Overview: Production error; immobilizer wire (orange/black) in pin position #4 instead of pin position #5. Although an effort to correct the issue was made, some quantity of harnesses did get shipped before the issue was spotted. We are advising to inspect the harness BLADE connector before attempting to install the harness and program the module.

Descripción general: El nuevo arnés en T FTI-STP1 requiere modificaciones para su uso en aplicaciones de transmisión automática (AT).

FTI-STP1: Notas de instalación y configuración

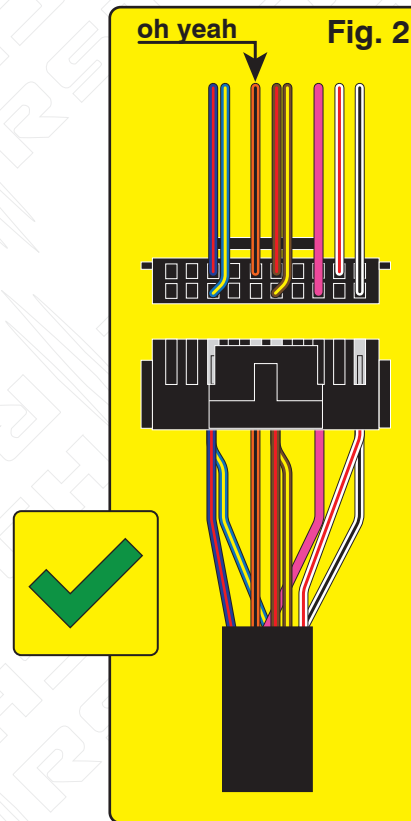
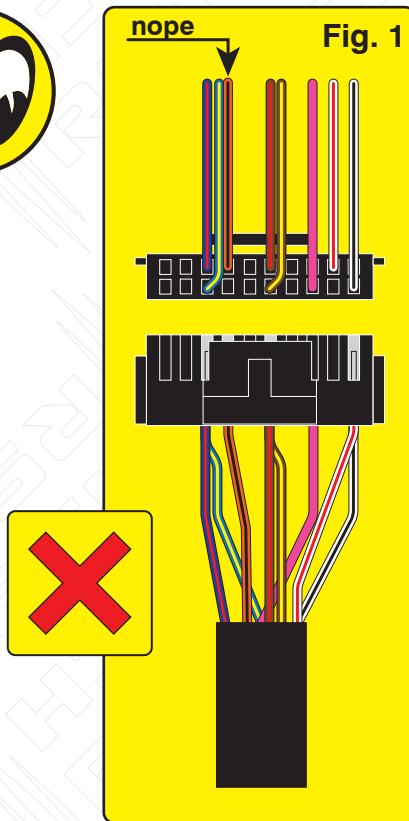
Issue: Module fails to program to vehicle, will not allow the vehicle to be remote started.

Correction: Step 1.) Locate the orange/black wire and confirm whether it is positioned as illustrated in Fig. 1 or Fig. 2. If the wire is as illustrated in Fig.1, proceed with Step 2 through 5 and complete the repair procedure outlined, if the wire is as illustrated in Fig. 2, correction is not necessary, proceed with harness installation and module programming.

Step 2.) Using a pick, lightly depress the catch that secures the terminal in the housing then remove the wire and terminal from the housing.

Step 3.) Using a fine tip razor or utility knife, insert the blade beneath the terminal catch and raise it slightly, so that it can be reused to secure the terminal when reinserted into the BLADE connector housing.

Step 4.) Refer to Fig. 2 for correct position of the orange/black wire (next to brown/red) then reinsert the terminal, pressing lightly until the catch 'snaps' into place, securing the terminal in the connector housing.

Step 5.) The repair is complete, proceed with installation and programming.

MODIFICACIÓN REQUERIDA PARA APLICACIONES DE TRANSMISIÓN AUTOMÁTICA ÚNICAMENTE

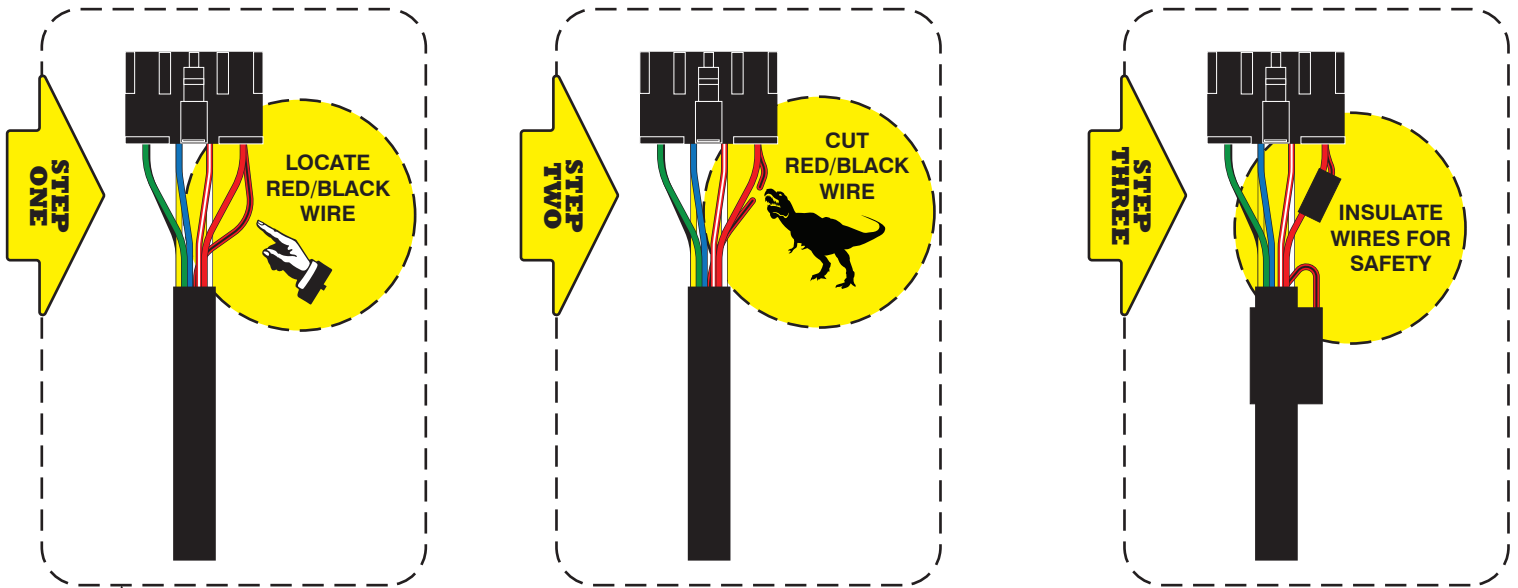
Problema: El arnés en T FTI-STP1 ha sido diseñado para ser compatible con AT (transmisión automática) y MT (transmisión manual), pero debido a una supervisión de la producción, el mecanismo de selección se estableció por defecto en el modo MT.

El uso de un arnés configurado para una aplicación MT, en un vehículo equipado con AT, podría provocar daños en el módulo del vehículo. Se recomienda que el arnés vuelva al modo AT antes de instalarlo en vehículos equipados con transmisión automática.

Corrección: Localice el cable rojo/negro (+ embrague) provisto en el conector CN1 del conjunto del arnés principal. Corte el cable rojo / negro, ya sea al ras del conector CN1 o dejando suficiente cable expuesto para que pueda aislar y asegure los extremos del alambre que quedan después del corte. Aísle cada uno de los extremos restantes del cable rojo/negro y asegúrelos para evitar cualquier posibilidad de cortocircuito.

C SE REQUIERE MODIFICACIÓN PARA LA TRANSMISIÓN AUTOMÁTICA

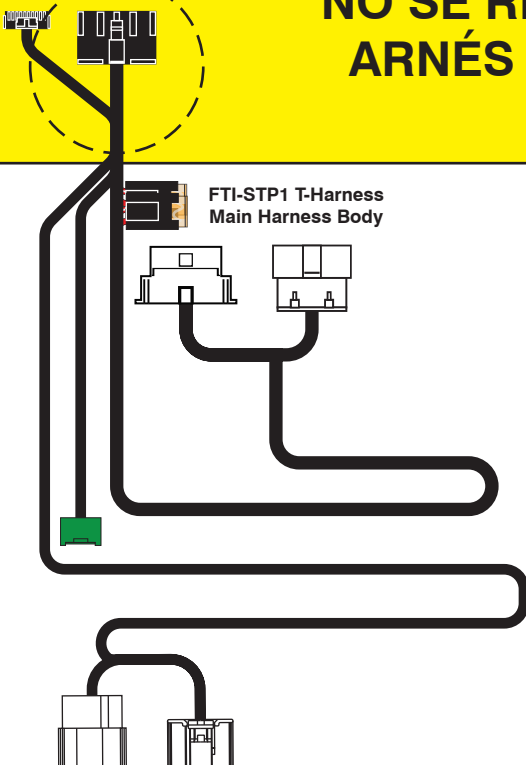
Controladores de las series CMX, CM7 y CM9: no se requieren cambios de configuración. Consulte la página anterior para conocer las modificaciones necesarias. en la posición de salida de la luz de estacionamiento del conector CN1 (+ embrague).
